A d d e n d u m

Iowa Department of Transportation
Office of Contracts

B.O.	Proposal ID	Proposal Work Type	County	Project Number	Addendum
110	97-0121-031	PCC SIDEWALK/TRAIL	WOODBURY	NHSN-012-1(31)--2R-97	17JUN110.A01

SHEET S.6

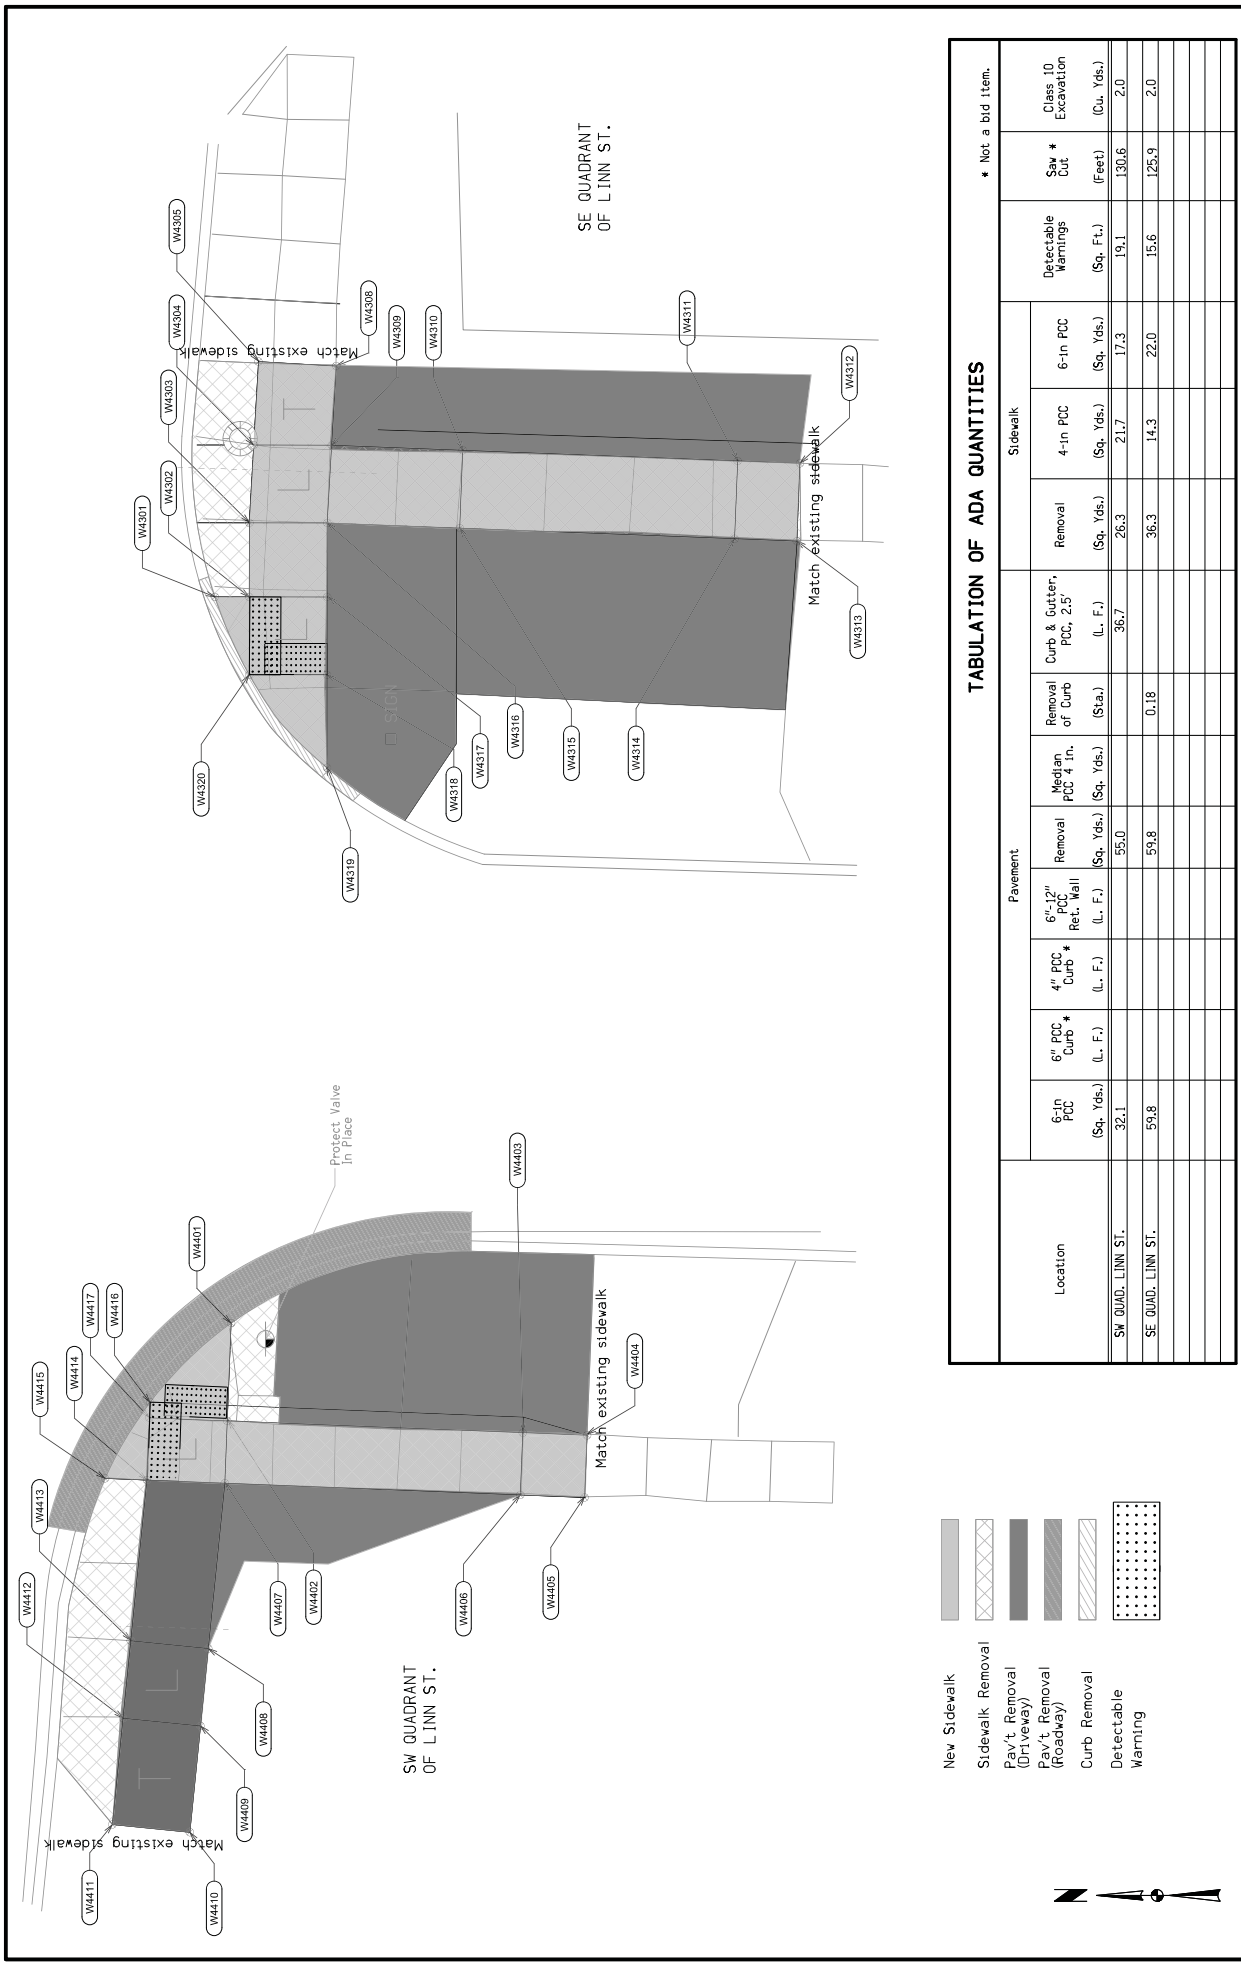
1. SW Quadrant of Linn St., in the Pavement Section column for 6-in PCC (Sq. Yds.) add 32.1.
2. SW Quadrant of Linn St., in the Pavement Section column for Removal (Sq. Yds.) revise number to 55.0 (from 44.8).
3. SW Quadrant of Linn St., in the Sidewalk Section column for 4-in PCC (Sq. Yds.) revise number to 21.7 (from 22.8).
4. SW Quadrant of Linn St., in the Sidewalk Section column for 6-in PCC (Sq. Yds.) revise number to 17.3 (from 5.1).
5. SE Quadrant of Linn St., in the Pavement Section column for Removal (Sq. Yds.) revise number to 59.8 (from 60.4).
6. SE Quadrant of Linn St., in the Pavement Section column for 6-in PCC (Sq. Yds.) add 59.8.
7. SE Quadrant of Linn St., in the Sidewalk Section column for 4-in PCC (Sq. Yds.) revise number to 14.3 (from 25.1).
8. SE Quadrant of Linn St., in the Sidewalk Section column for 6-in PCC (Sq. Yds.) revise number to 22.0 (from 5.3).

SHEET S.7

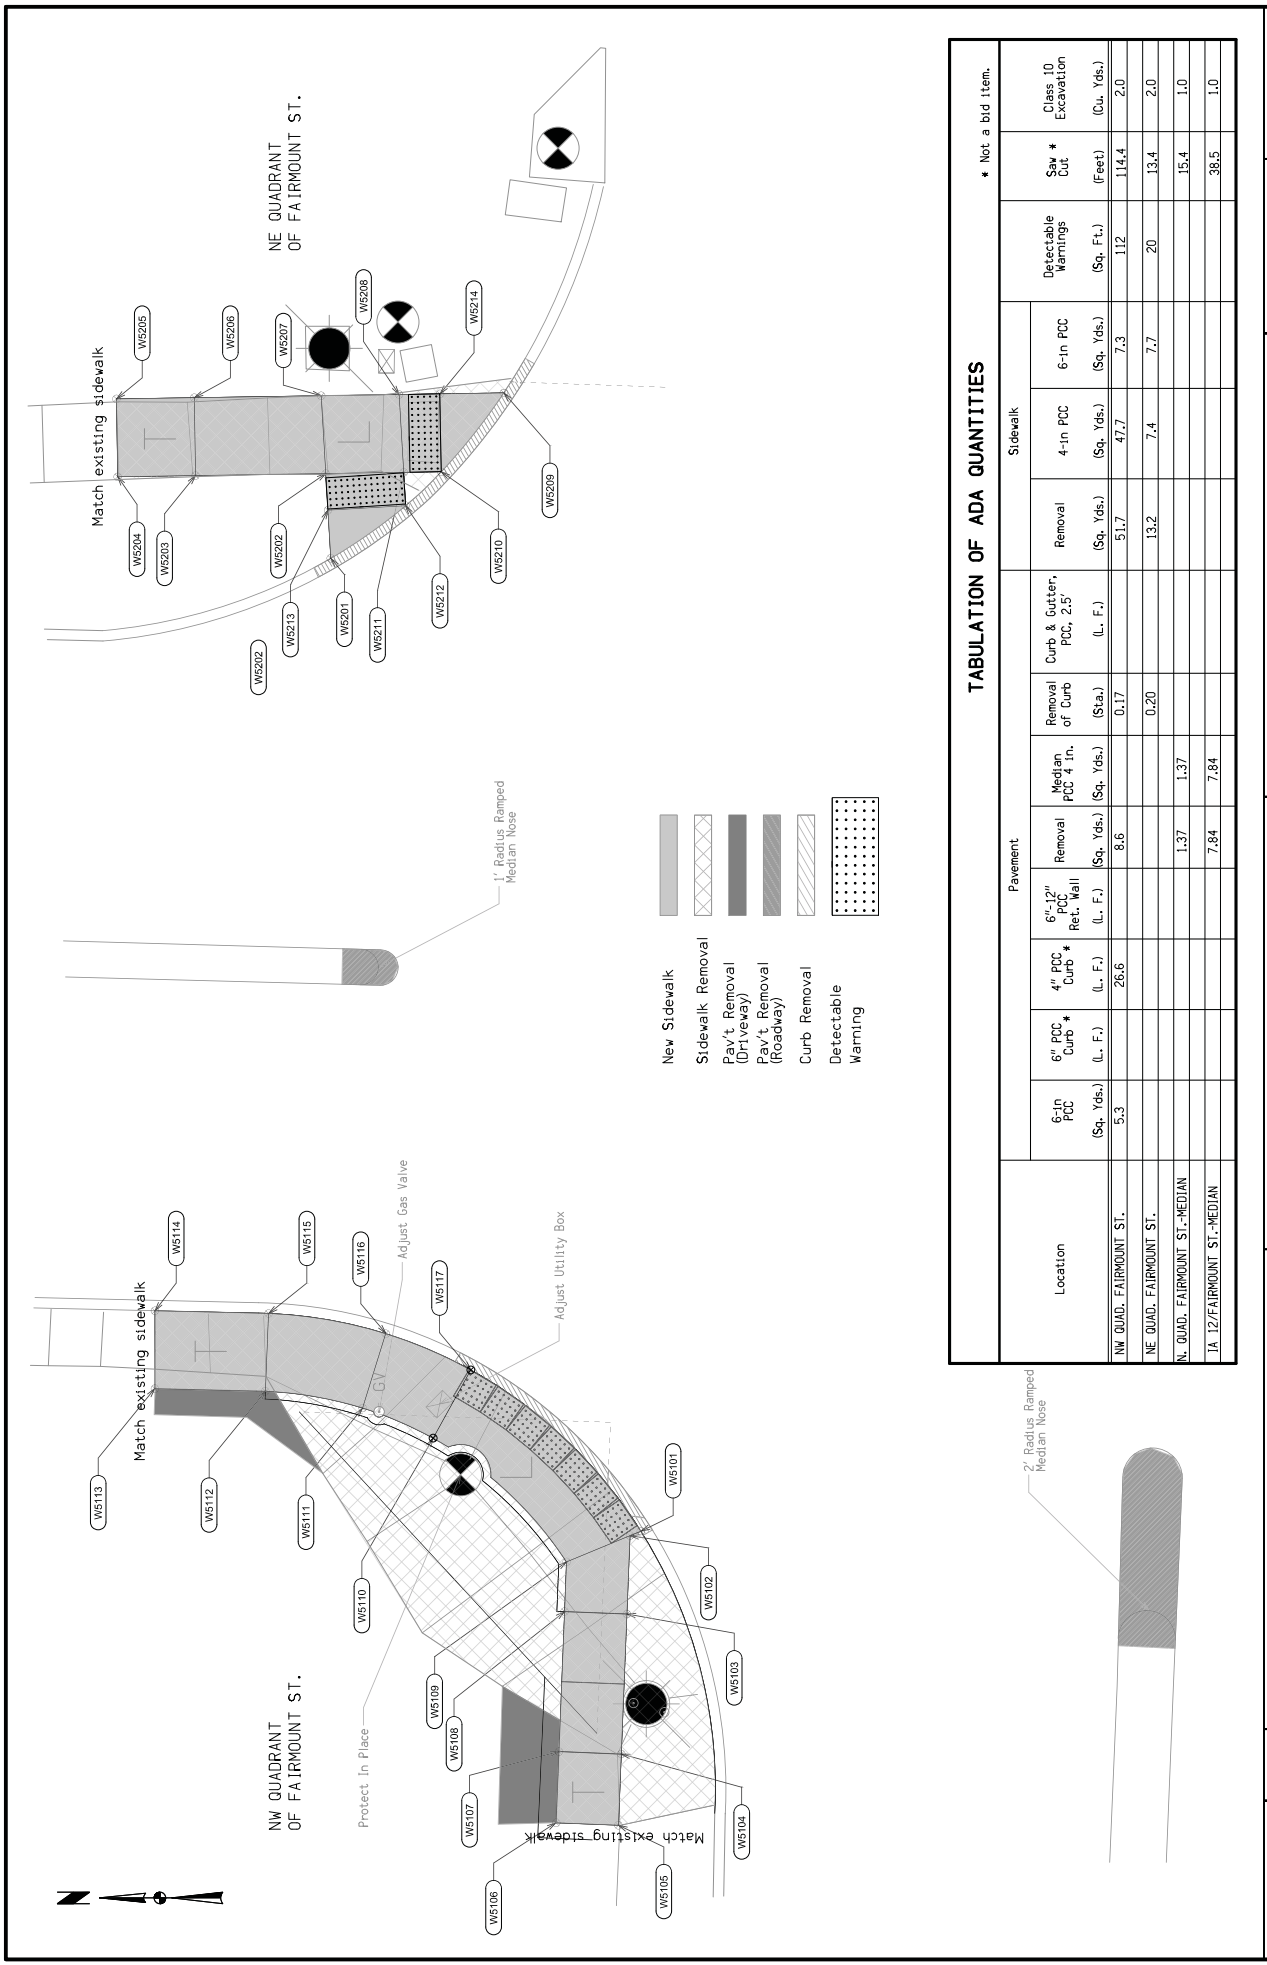
1. NW Quadrant of Fairmount St., in the Pavement Section column for 6-in PCC (Sq. Yds.) add 5.3.
2. NW Quadrant of Fairmount St., in the Pavement Section column for Removal (Sq. Yds.) revise number to 8.6 (from 5.3).
3. NW Quadrant of Fairmount St., in the Sidewalk Section column for Removal (Sq. Yds.) revise number to 51.7 (from 55.0).
4. NW Quadrant of Fairmount St., in the Sidewalk Section column for 4-in PCC (Sq. Yds.) revise number to 47.7 (from 18.7).
5. NW Quadrant of Fairmount St., in the Pavement Section column for 4-IN PCC Curb (L.F.)* add 26.6.
6. NE Quadrant of Fairmount St., in the Sidewalk Section column for 4-in PCC (Sq. Yds.) revise number to 7.4 (from 10.3).
7. NE Quadrant of Fairmount St., in the Sidewalk Section column for 6-in PCC (Sq. Yds.) revise number to 7.7 (from 10.3).

SHEET S.8

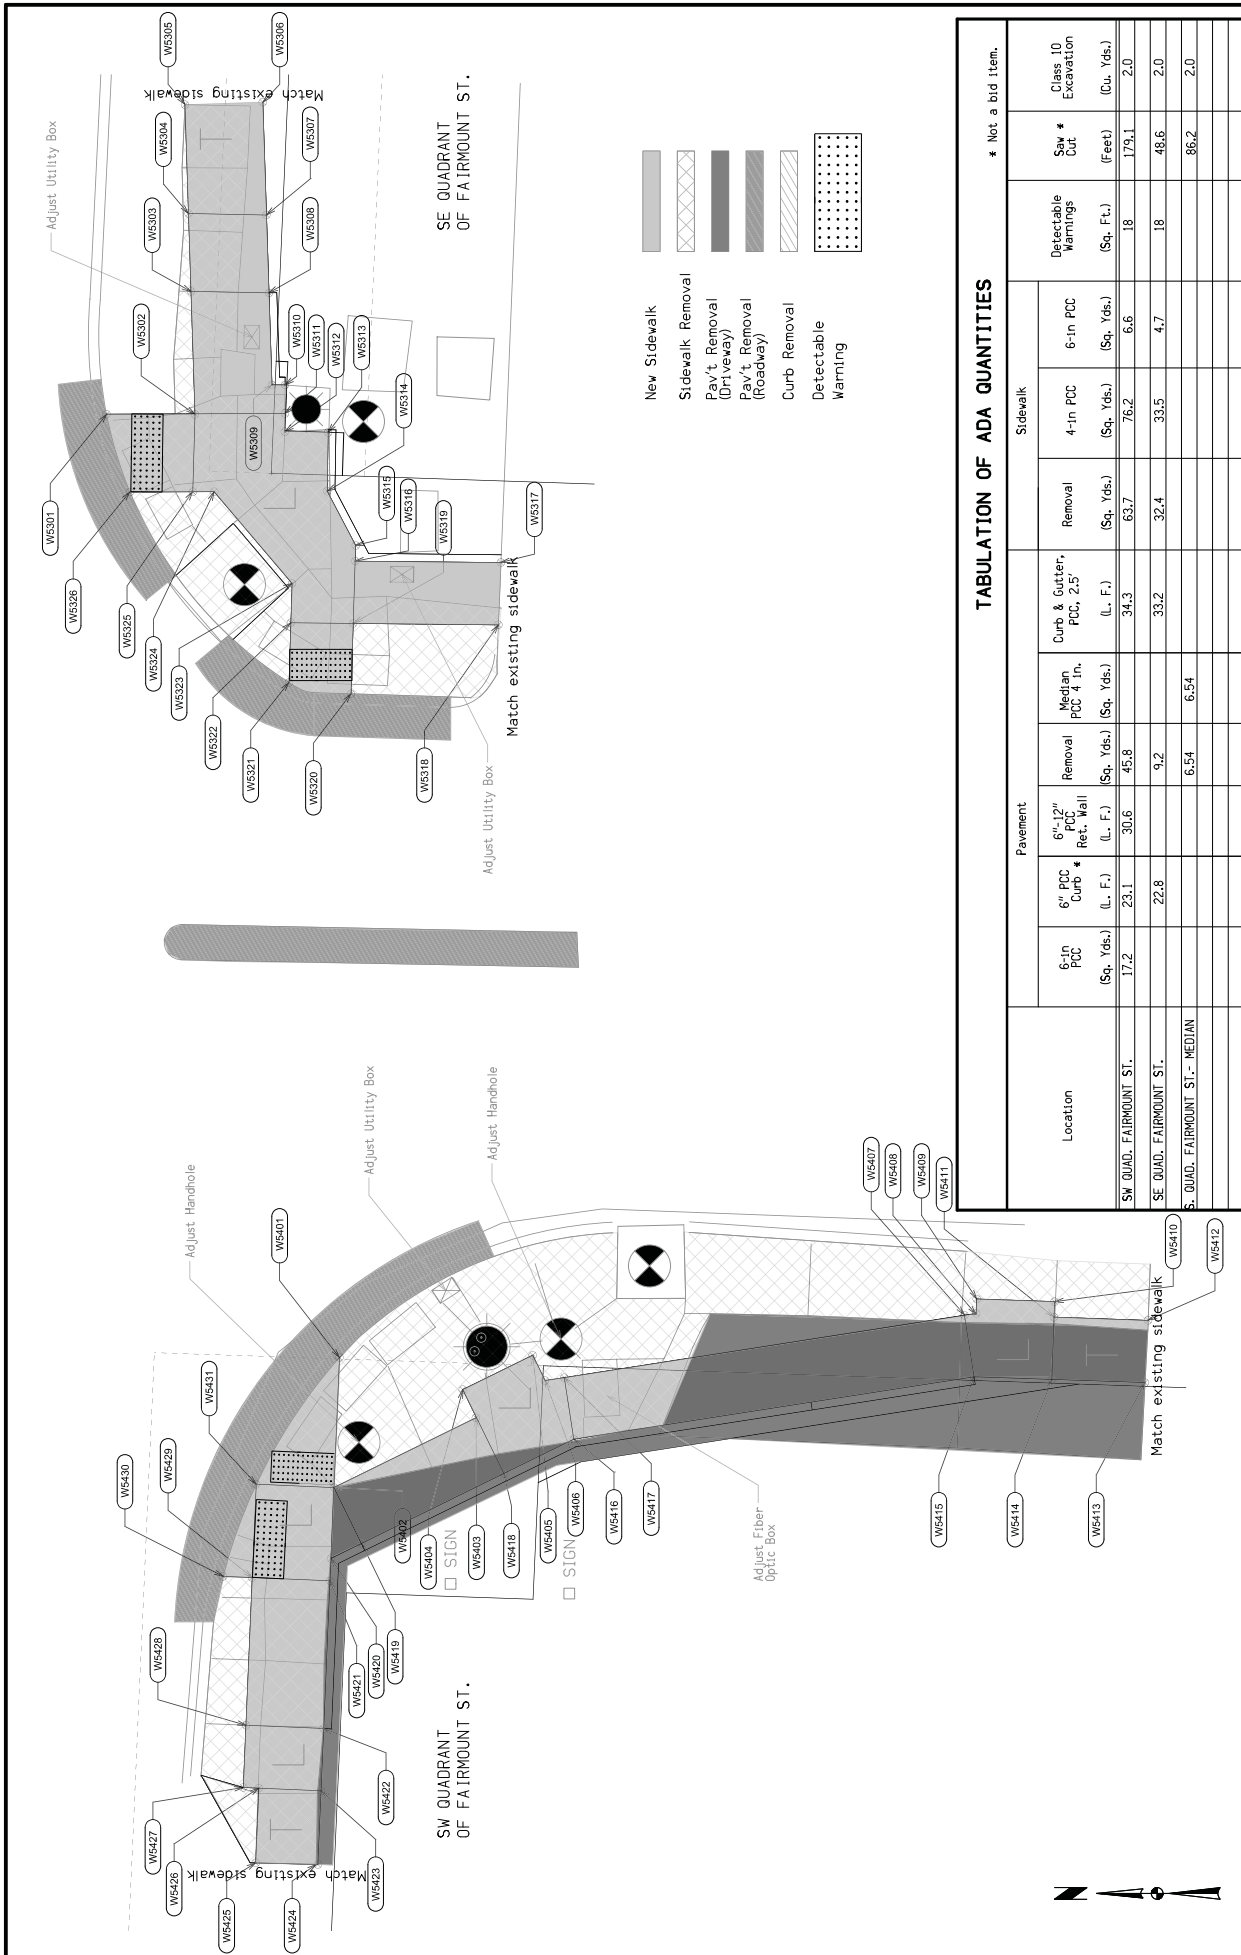
1. SW Quadrant of Fairmount St., in the Pavement Section column for 6-in PCC (Sq. Yds.) add 17.2.
2. SW Quadrant of Fairmount St., in the Pavement Section column for 6"- 12" PCC Ret. Wall (L.F.) add 30.6.

3. SW Quadrant of Fairmount St., in the Pavement Section column for Removal (Sq. Yds.) revise number to 45.8 (from 36.3).
4. SW Quadrant of Fairmount St., in the Pavement Section column for 6-IN PCC Curb (L.F.)* add 23.1.

5. SW Quadrant of Fairmount St., in the Sidewalk Section column for 4-in PCC (Sq. Yds.) revise number to 76.2 (from 35.4).
6. SW Quadrant of Fairmount St., in the Sidewalk Section column for 6-in PCC (Sq. Yds.) revise number to 6.6 (from 6.5).

7. SE Quadrant of Fairmount St., in the Pavement Section column for Removal (Sq. Yds.) add 9.2.
8. SE Quadrant of Fairmount St., in the Sidewalk Section column for 4-in PCC (Sq. Yds.) revise number to 33.5 (from 24.9).

9. SE Quadrant of Fairmount St., in the Sidewalk Section column for Removal (Sq. Yds.) revise number to 32.4 (from 35.4).
10. SE Quadrant of Fairmount St., in the Pavement Section column for 6-IN PCC Curb (L.F.)* add 22.8.
